VARIANCE / FIELD CHANGE NOTICE

V/F: 21130-PSP-0001-11

PROJECT TITLE: Project Specific Plan for Area 9, Phase II Precertification Real-Time Scan

FIGURE 1. A9P11 EXCAVATION PLAN

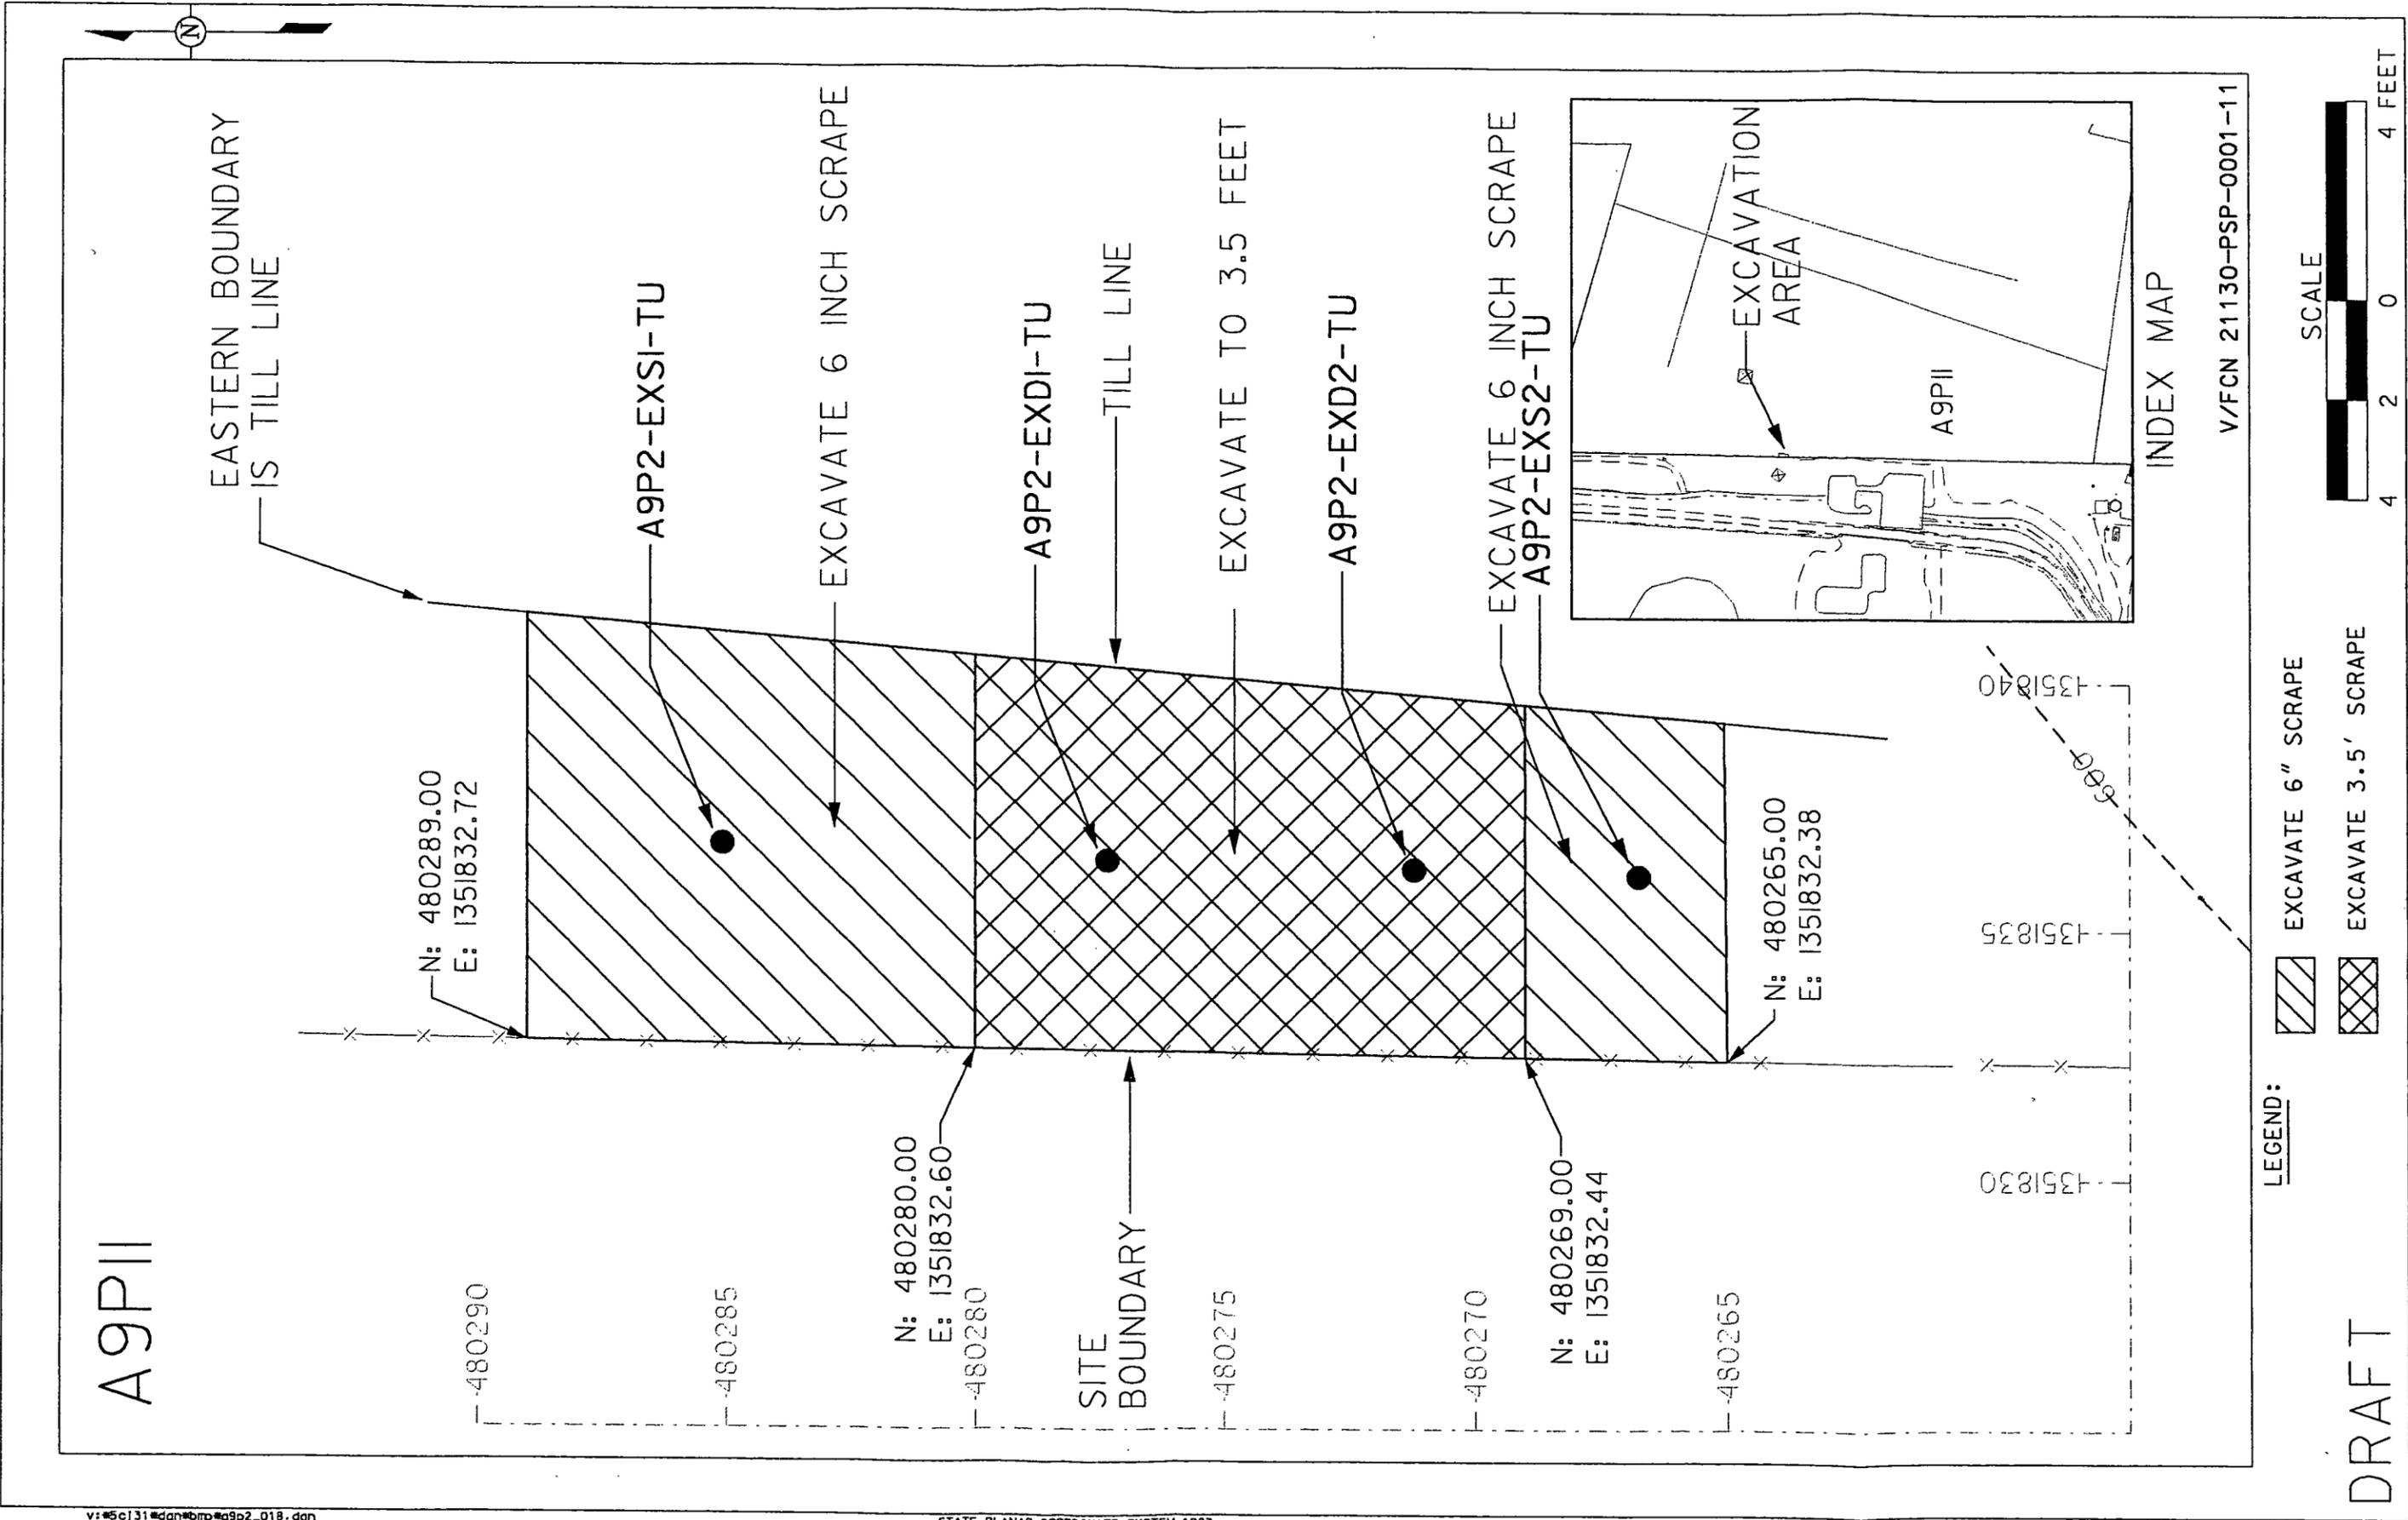
This Variance/Field Change Notice (V/FCN) documents the collection of physical samples in from the excavated area from Area 9, Phase II (A9P2) located off-property east of the Fernald Closure Project.

Four samples will be collected for total uranium (TAL B) analysis after the excavation of above-FRL (50 ppm) soil is complete. The samples will be collected from the floor of the excavated area – two samples will be from the floor of the deep excavated area and one sample will be collected from the floor of each of the two shallow excavated areas (see Figure 1 for excavation plan). The samples will be submitted to the onsite laboratory for analysis. See Attachment 1 for the Sampling and Analytical Requirements.
